Access Compliance Report

Public Rights-of-Way

(Curb Ramps)

Intersection ID: 49296	Main Street: CREEKSIDE_PARK_RD	Cross Street: ARDREY_CREST_DR	Location: NW
ADA ID: 19744E553757	Ramp Type: PerpDiag	Initial Pass/Fail: Fail	Overall Compliance: No
Severity Score: 12.5			
Codes/Mitigation Info/Possible Solution		Field Measurements/Component Compliance

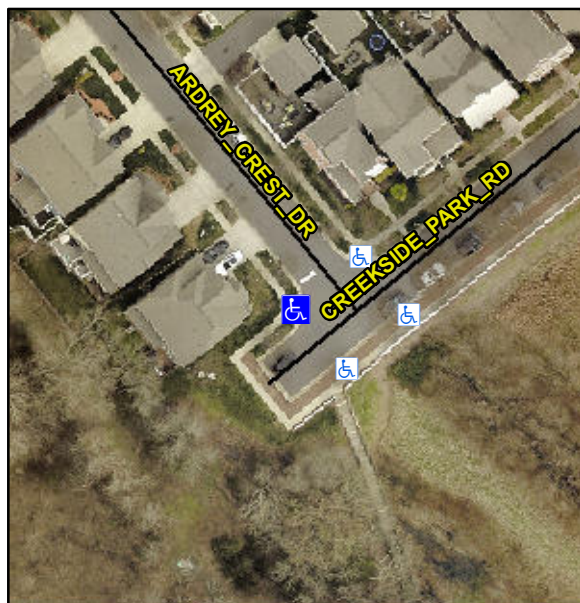
Not Found, R304.2.2

Compliance	Description	Data	Compliance	Description	Data
N/A	Ramp Length (in)	70.0	No	Ramp Slope (%)	8.6
Yes	Ramp Width (in)	48.0	Yes	Ramp XSlope (%)	1.2
N/A	Flare Type LT	N/A	N/A	Flare Type RT	N/A
N/A	Flare Slope LT (%)	N/A	N/A	Flare Slope RT (%)	N/A
N/A	Flare Traversable LT?	N/A	N/A	Flare Traversable RT?	N/A
N/A	Landing Length (in)	N/A	N/A	DWS Provided?	N/A
N/A	Landing Width (in)	N/A	N/A	DWS Contrast?	N/A
N/A	Landing Slope (%)	N/A	N/A	DWS Length (in)	N/A
N/A	Landing X Slope (%)	N/A	N/A	DWS Full Width?	N/A
N/A	Landing Curb? (Y/N)	N/A	N/A	DWS Offset (in)	N/A
N/A	Shared Landing?	N/A			
N/A	Gutter Ponding?	N/A	N/A	Gutter Slope (%)	N/A
N/A	Gutter Lip Ht (in)	N/A	N/A	Gutter X Slope (%)	N/A
N/A	Painted X Walk1?	No	N/A	Painted X Walk2?	No
	X Walk 1 Direction	To SE		X Walk 2 Direction	To NE
N/A	X Walk 1 Width (in)	N/A	N/A	X Walk 2 Width (in)	N/A
	X Walk 1 Slope (%)	3.0		X Walk 2 Slope (%)	0.7
	X Walk 1 X Slope (%)	0.9		X Walk 2 X Slope (%)	2.0

Remove & Replace Curb Ramp With Two New Directional Ramps or Equivalent.
